To: All Plan Holders of Record

Re: *Addendum No. 1*
Jefferson Booster Station Replacement
Ashtabula County Board of Commissioners, OH

Date: July 17, 2026

JEFFERSON BOOSTER STATION REPLACEMENT
JEFFERSON, OHIO
ASHTABULA COUNTY
STANDARD DETAILS - SD SERIES
1- CONSTRUCTION DETAILS

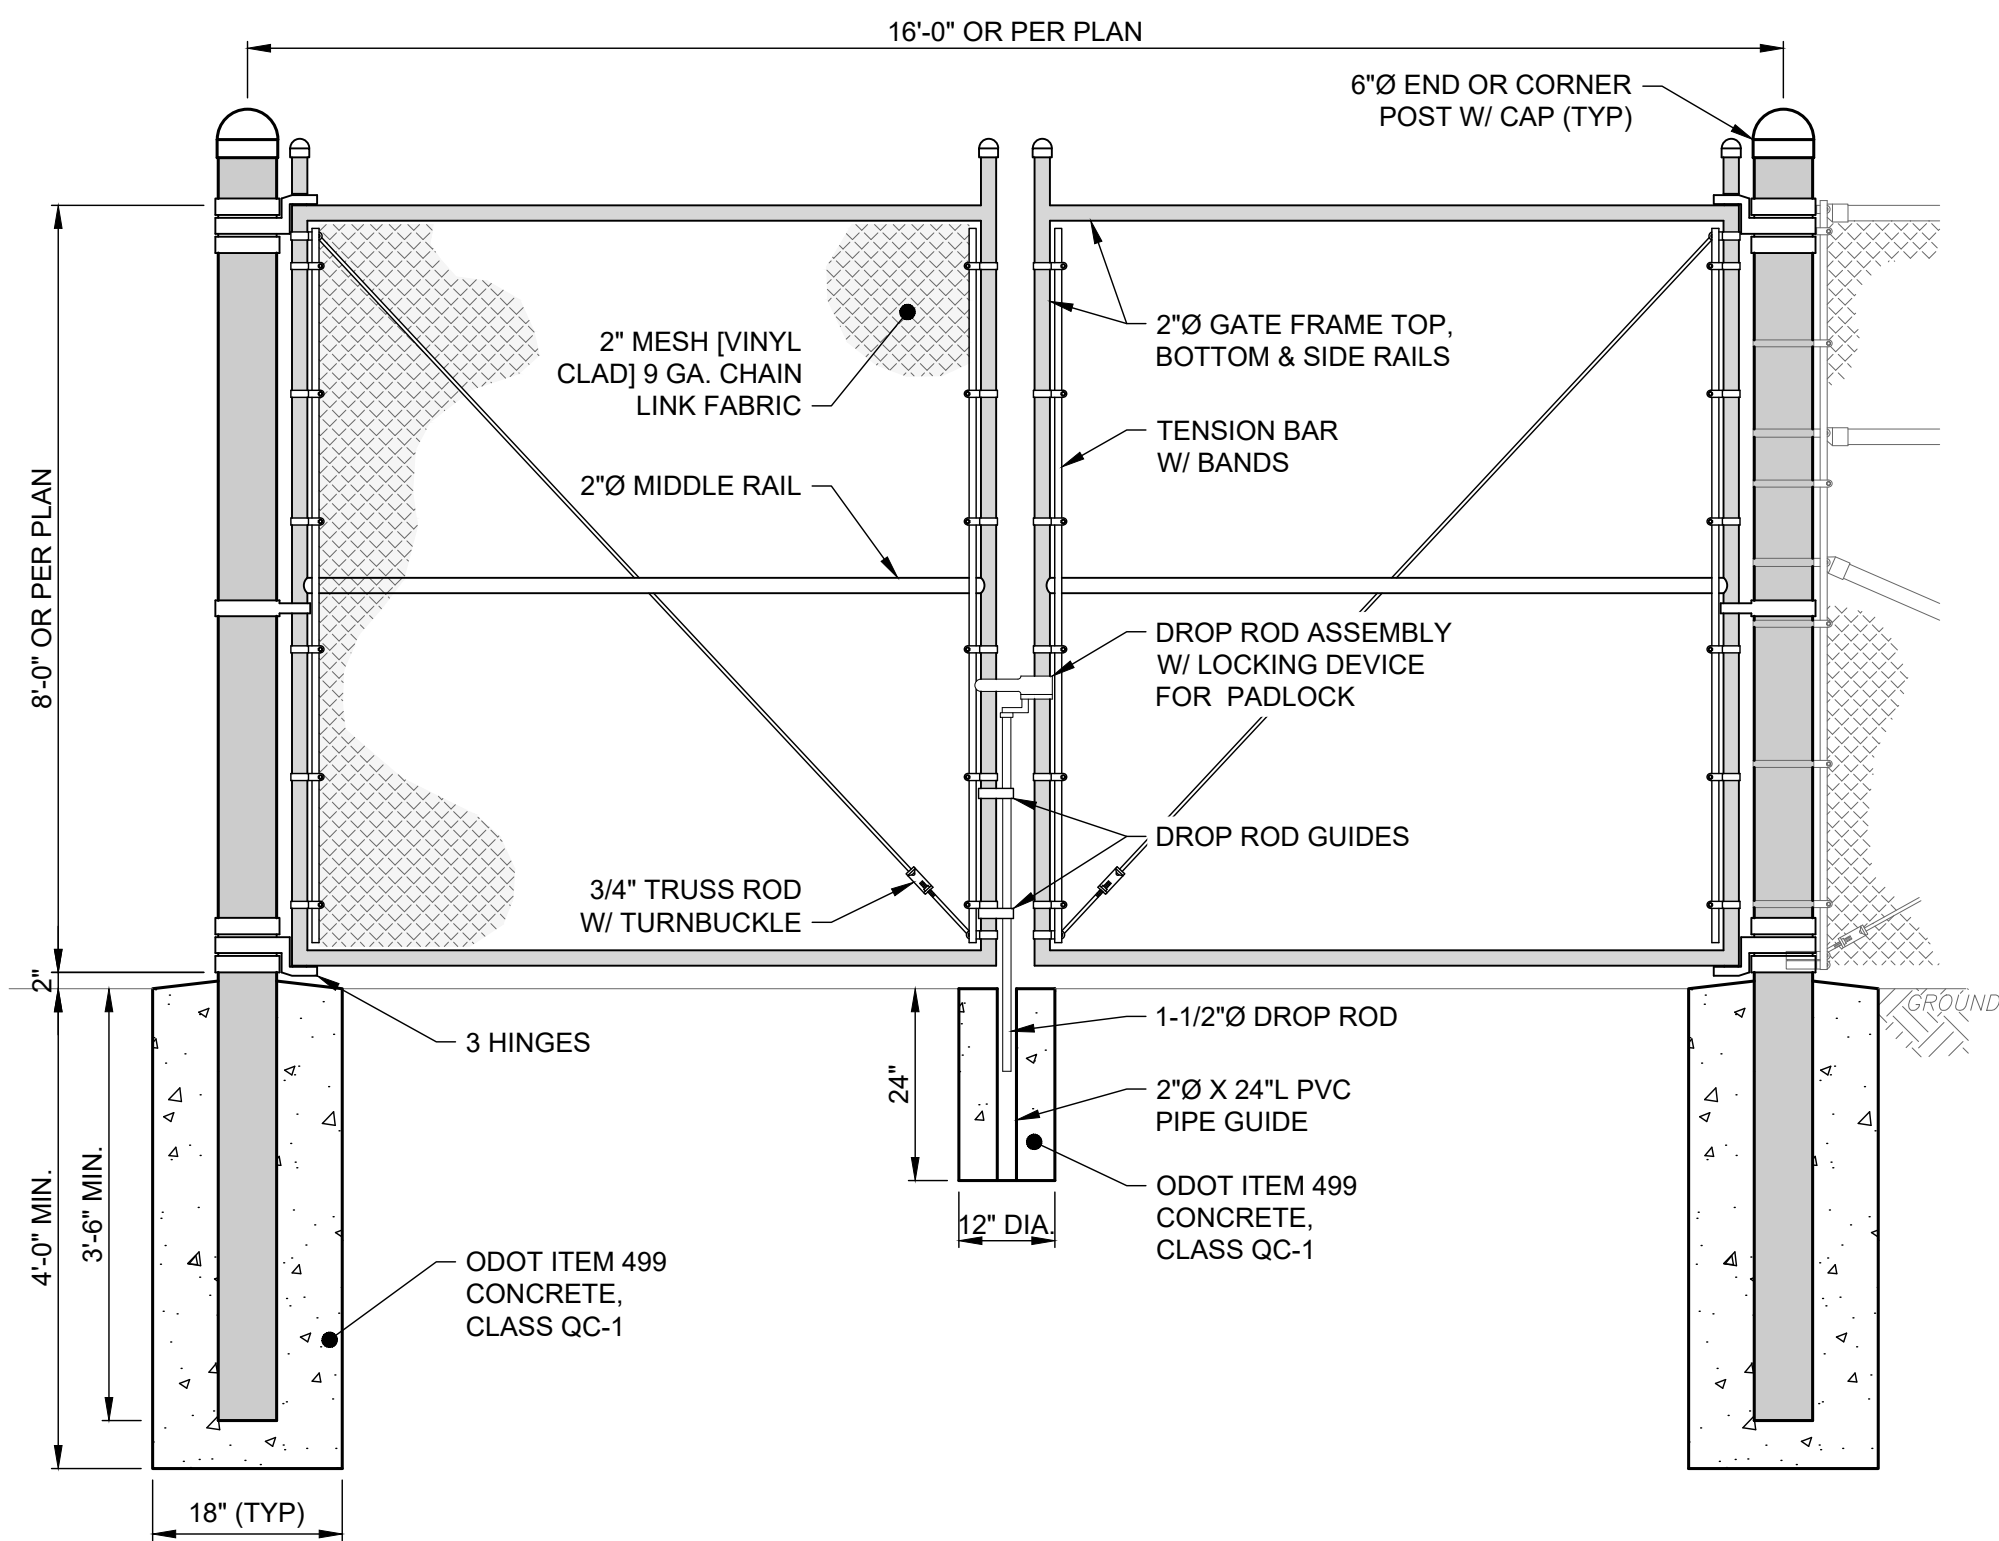
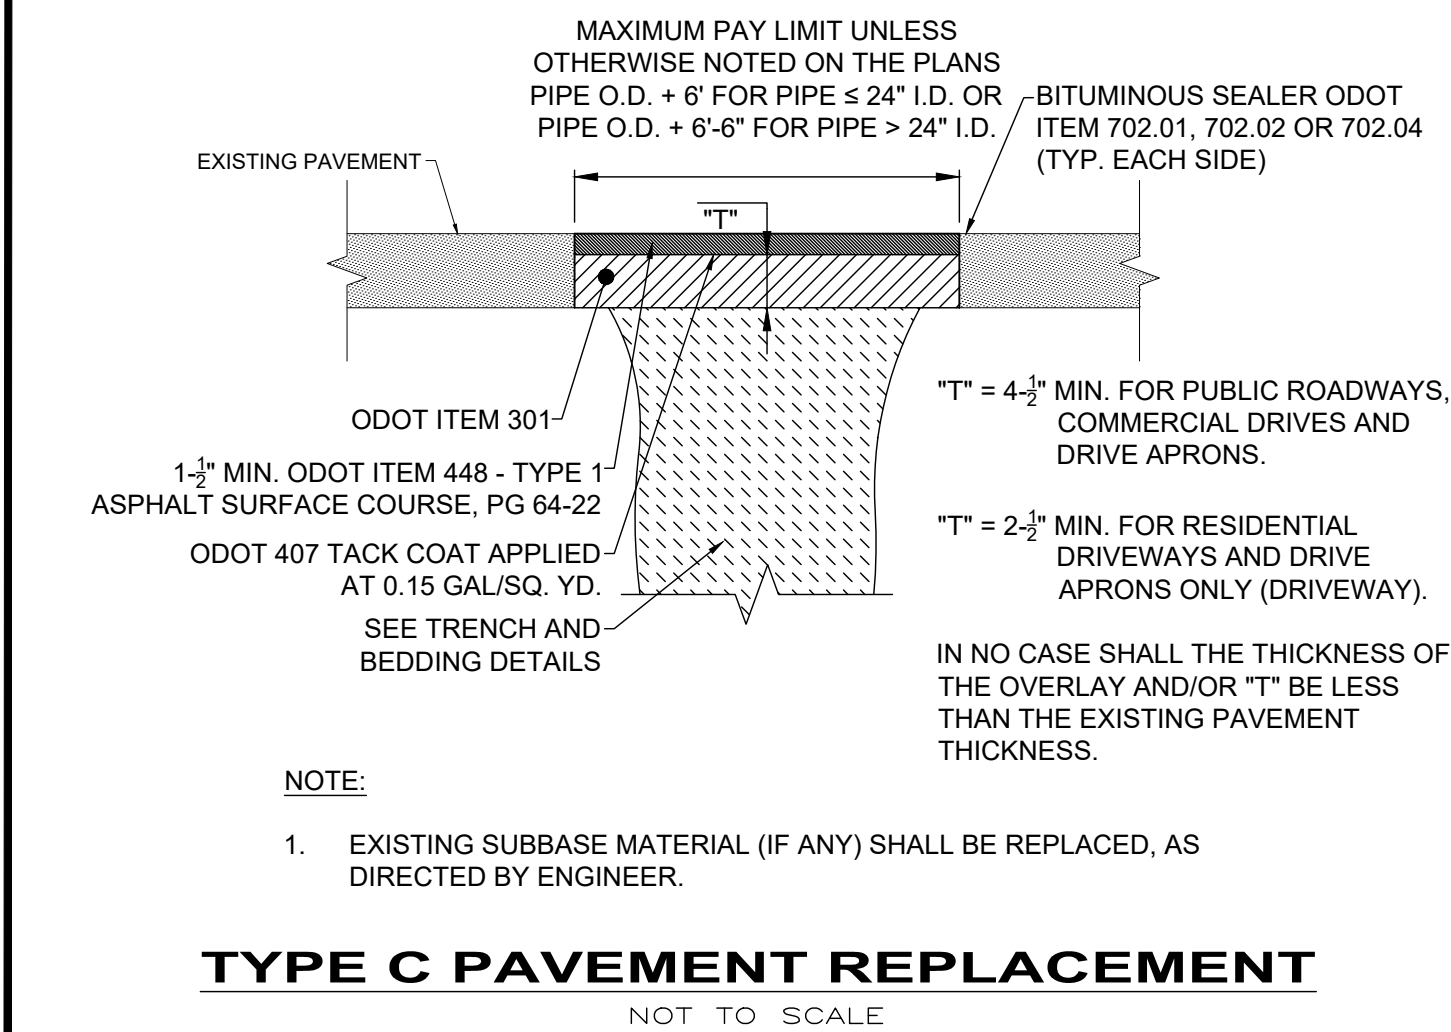
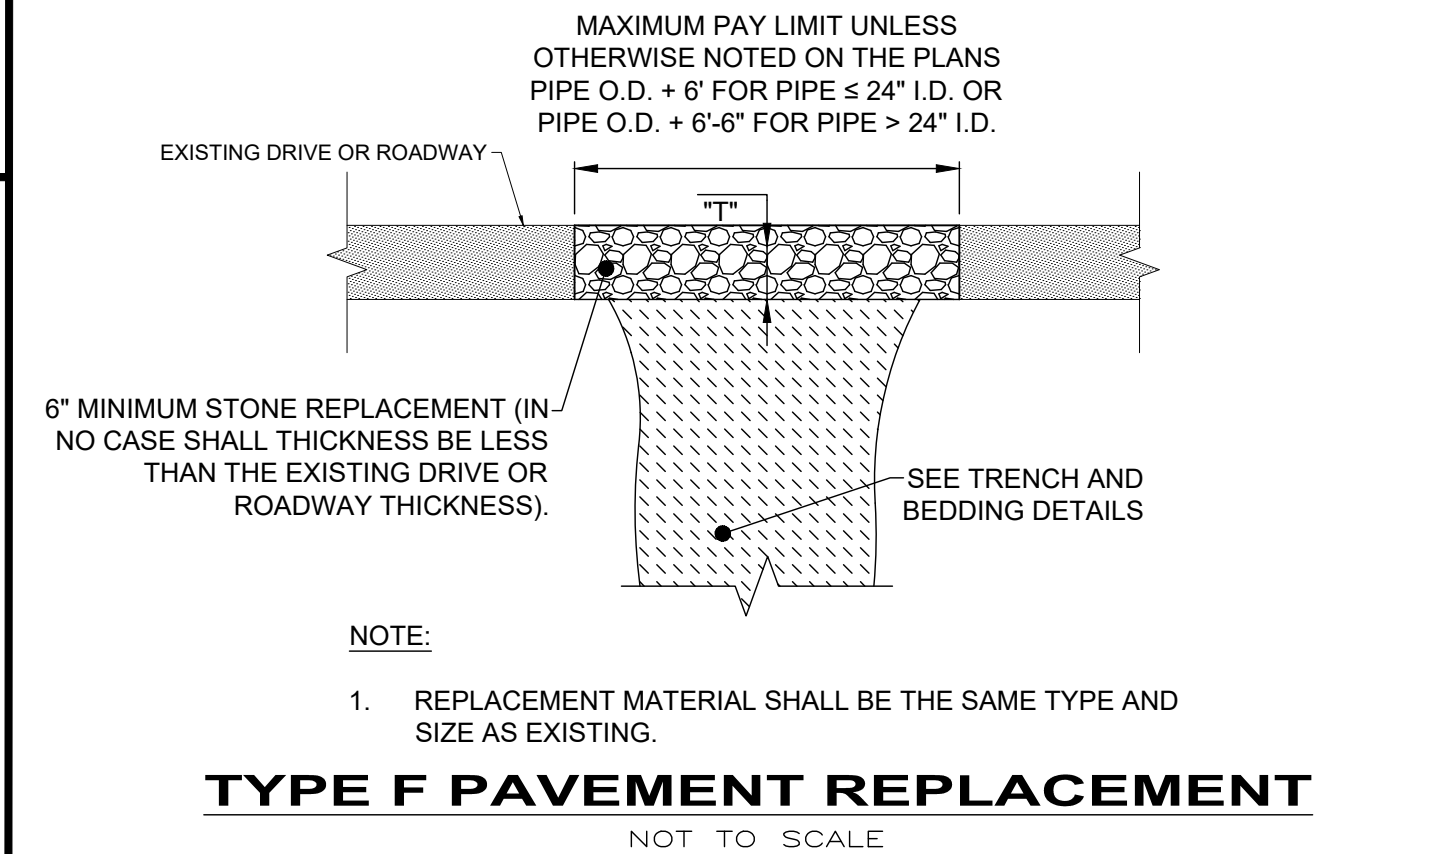
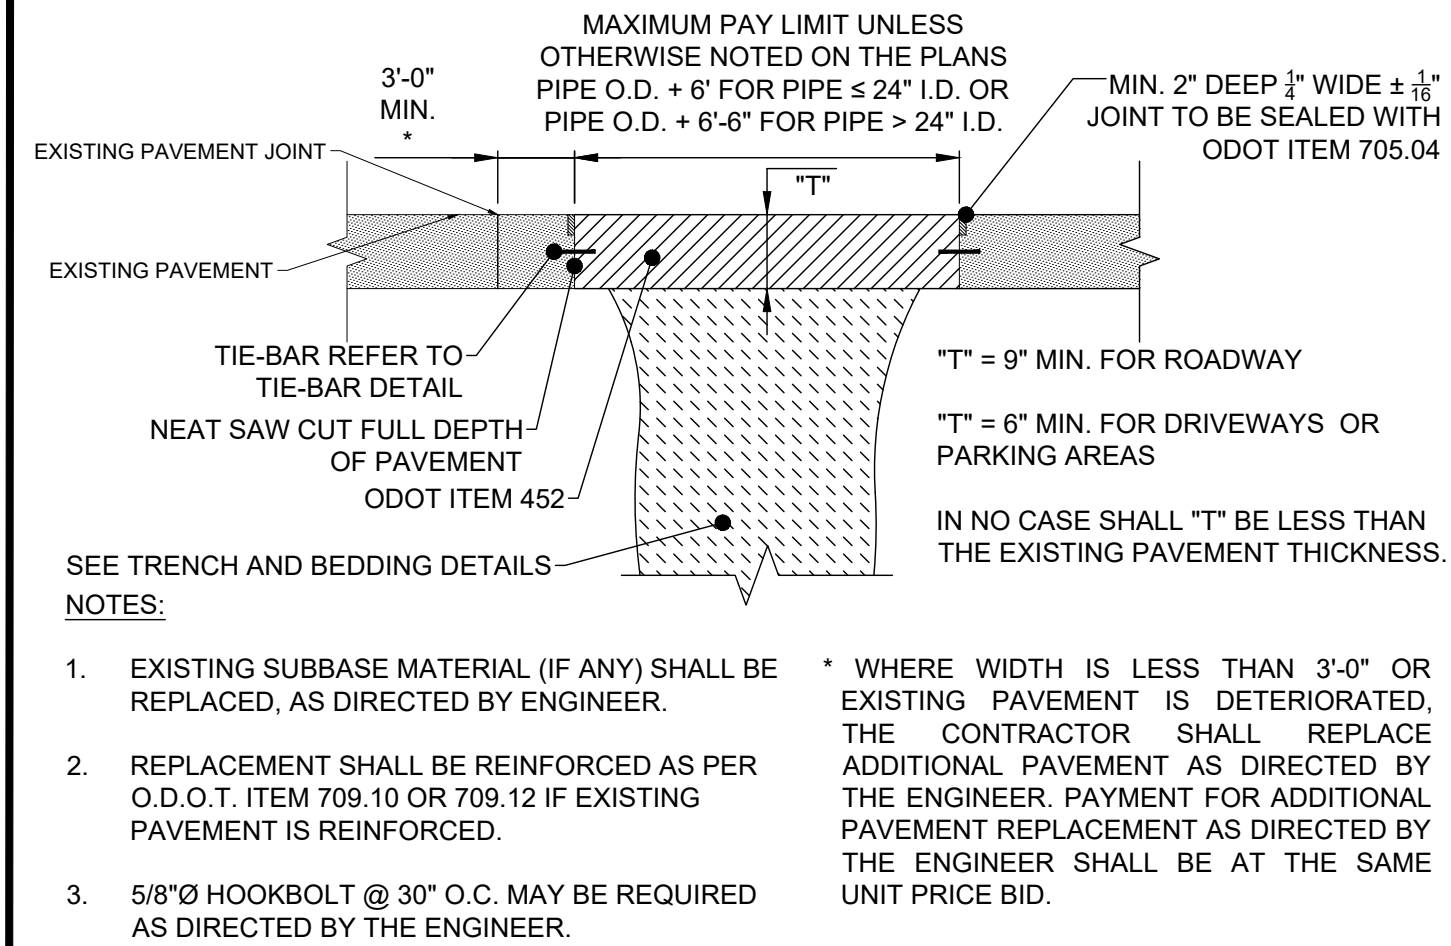
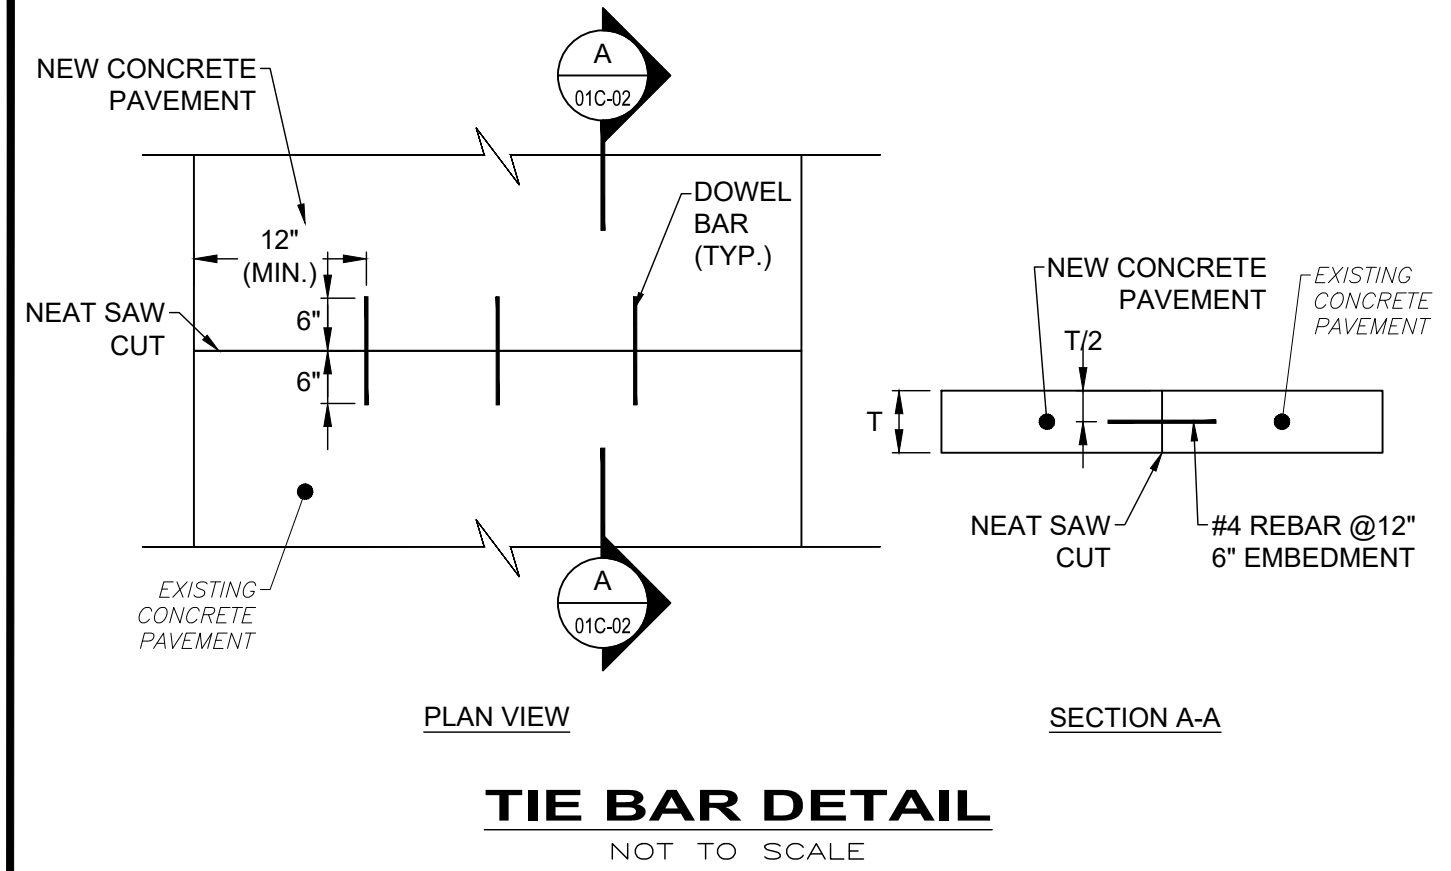
Q1. Can you provide a detail for the generator and an overall size to include the load center?

Replace 1-CONSTRUCTION DETAILS, sheet 15/17 with the enclosed 1-CONSTRUCTION DETAILS, sheet 15/17.

A1. See enclosed Sheet 15/17 for generator pad detail.
